Groundwater Application Review Summary Form

Application # G- 18840 re-review

TO: **Application G- 18840 re-review**

TO: Water Rights Section Date 6/20/2023
 FROM: Groundwater Section Travis Brown
Reviewer's Name
 SUBJECT: Application G- 18840 re-review Supersedes review of 8/28/2019
Date of Review(s)

This Drawdown Analysis

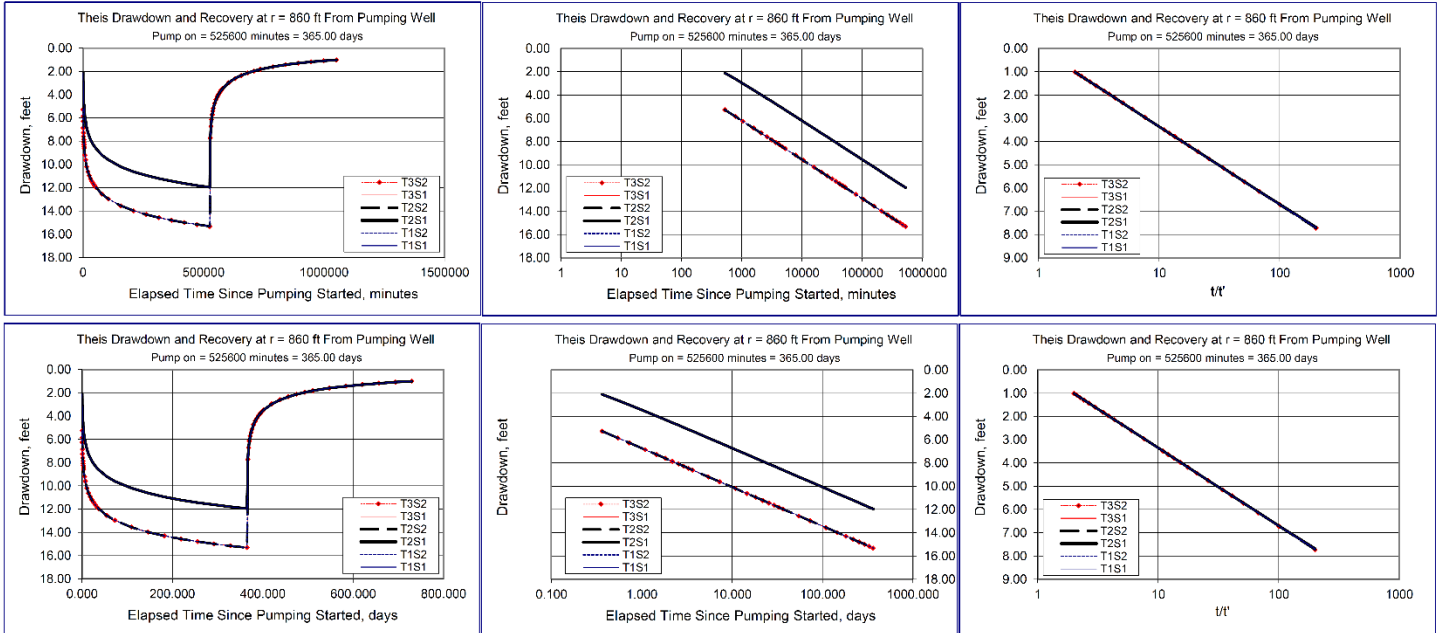
The nearest senior groundwater right producing from similar water-bearing zones as the proposed POA is MARI 143, authorized POA for Certificate 42114. MARI 143 is ~860 ft east of proposed POA 5. To assess the potential for injury to Certificate 42114 due to the proposed use, an analysis was conducted using the Theis (1935) equation for drawdown in a confined aquifer. Hydraulic parameters used for the analysis were derived from regional data and studies (Pumping Test Reports, Conlon et al., 2003, 2005; Iverson, 2002; McFarland and Morgan, 1996; Woodward et al., 1998) or are within a typical range of values for the given parameter within the hydrogeologic regime (Freeze and Cherry, 1979; Domenico and Mifflin, 1965). The applicant has noted in the Application that they have also submitted a Groundwater Registration Modification application (GR-MOD T-13221) which proposes to change the POA for Groundwater Registration GR-3351 to POA 1-5 as identified in this application. Per proposed GR-MOD T-13221, POA 1-5 would pump up to 0.25 cfs under GR-3351, in addition to the 0.45 cfs requested in this application. Therefore, the analysis used a combined rate of 0.7 cfs (~314 gpm) to assess potential injury to nearby senior users. **Results indicate that the proposed use is not likely to interfere with MARI 143 such that a senior groundwater user would be prevented from receiving water to which they are legally entitled (see This Drawdown Analysis, attached).**

Hydrograph - Spring

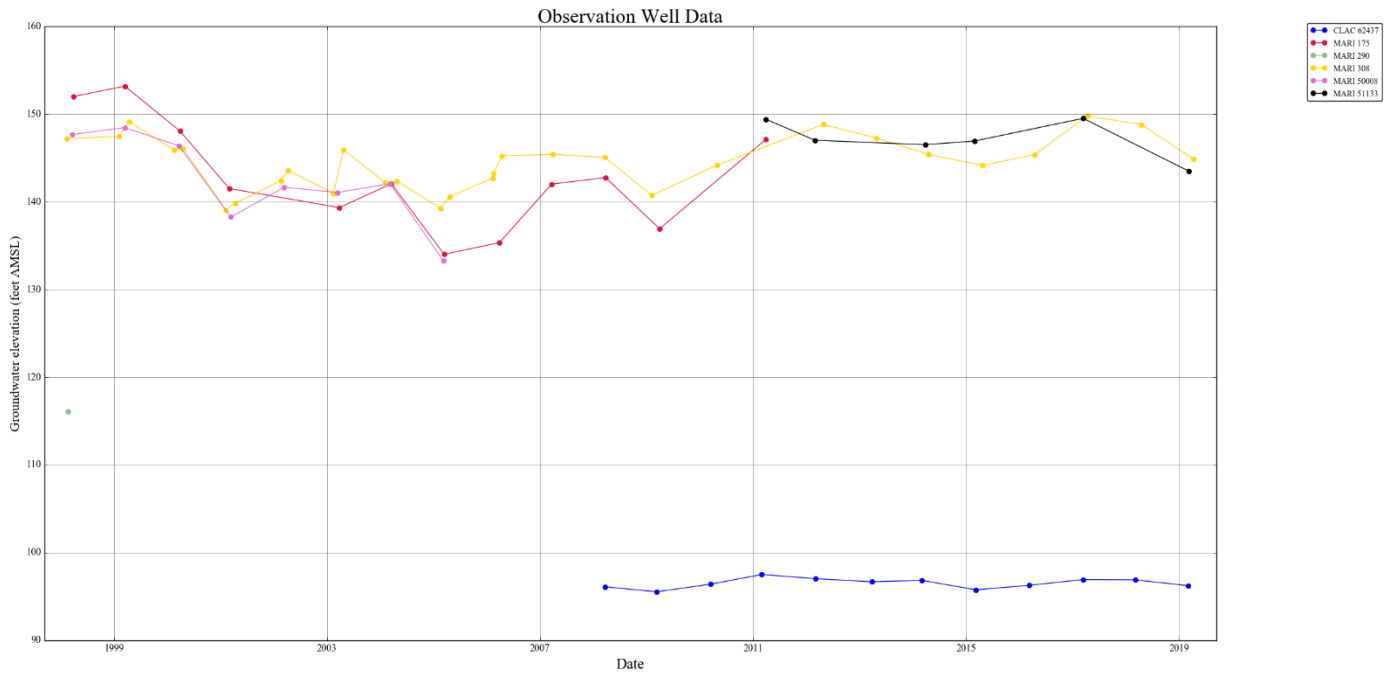
Hydrographs of water levels in the nearby alluvial aquifer system over the past two decades do not indicate widespread or persistent declines (see Hydrograph - Spring, attached). However, there do appear to be substantial (~30 ft or more) seasonal fluctuations in water level based on observations from a nearby State Observation Well (see Hydrograph – MARI 308, attached). Additionally, well completion statistics from the area indicate slight trends of deeper well completions and lower initial reported static water levels over time (see Well Completion Statistics, attached). **While there is not sufficient evidence**

Well Completion Statistics – 3S/1W-32 & 33, 4S/1W-3 & 4

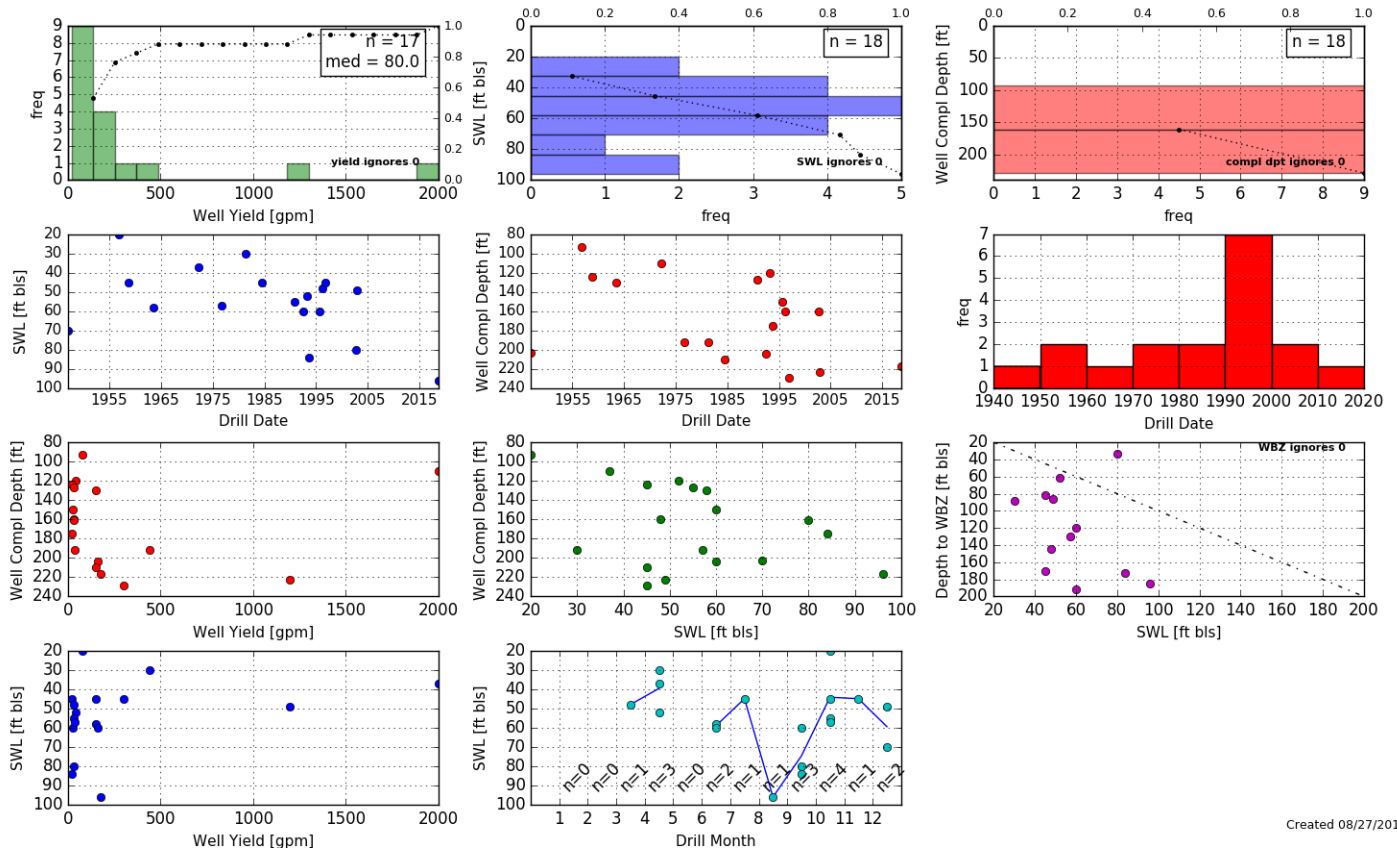
Basis for aquifer confinement evaluation: Reported static water level in MARI 68155 was greater than 80 ft above the noted water-bearing zone, indicating confined conditions. Well completion statistics from this area indicate that most completed wells have initial reported static water levels above the first noted water-bearing zone, also indicating confined conditions (see Well Completion Statistics, attached). Based on the available evidence, the aquifer appears to be confined in this area.

Stream Depletion Analysis – SW 1 (Willamette River)

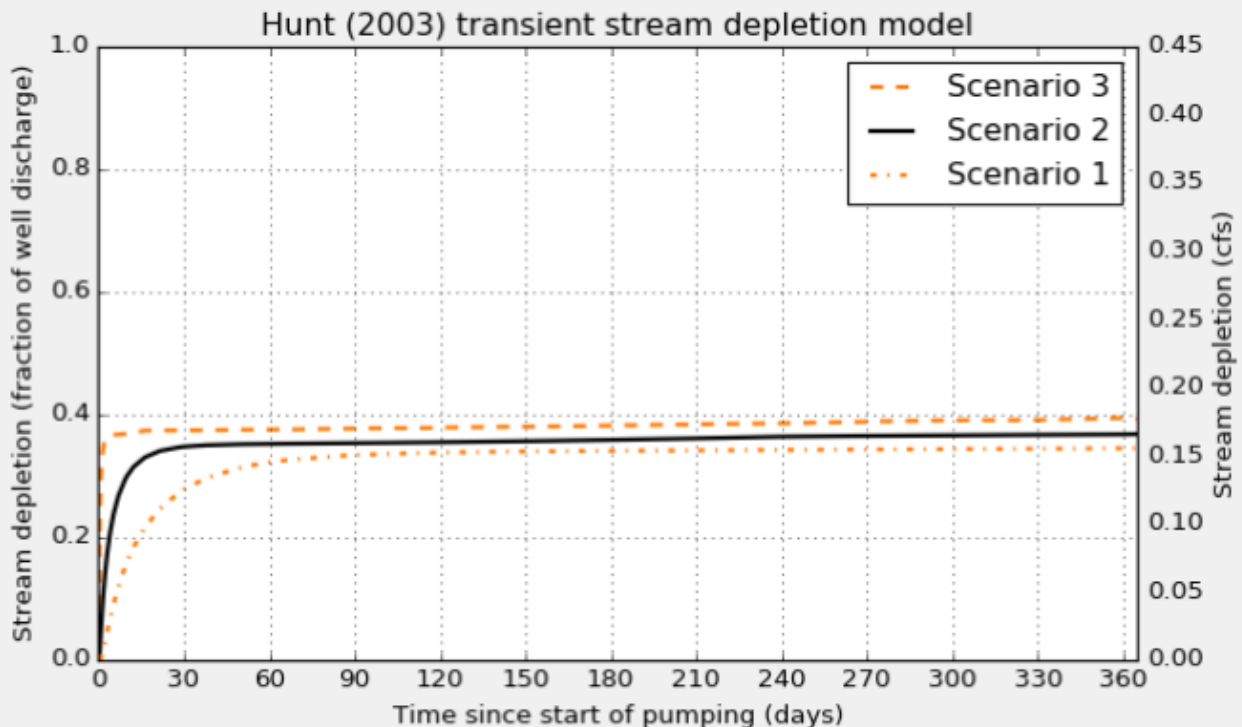
Comments: 3a: To assess the potential interference with surface water due to the proposed use, a stream depletion analysis was conducted using the Hunt (2003) analytical model. Hydraulic parameters used for the analysis were derived from regional data and studies (Pumping Test Reports, Conlon et al., 2003, 2005; Iverson, 2002; McFarland and Morgan, 1996; Woodward et al., 1998) or are within a typical range of values for the given parameter within the hydrogeologic regime (Freeze and Cherry, 1979; Domenico and Mifflin, 1965). Results of the analysis indicate that the proposed use will primarily impact SW 1 (Willamette River), with depletions of SW 1 most likely exceeding 25 percent of the rate of well discharge within 30 days of continuous use (see Stream Depletion Analysis, attached). The high relative rate of stream depletion is attributed primarily to the small intervening thickness of fine-grained sediments between the alluvial aquifer system and SW 1 (Willamette River) (i.e. a highly efficient hydraulic connection) and the confined nature of the alluvial aquifer. **Per OAR 690-009-0040(4)(d), the proposed use is assumed to have the potential to cause substantial interference (PSI) with SW 1 (Willamette River).**
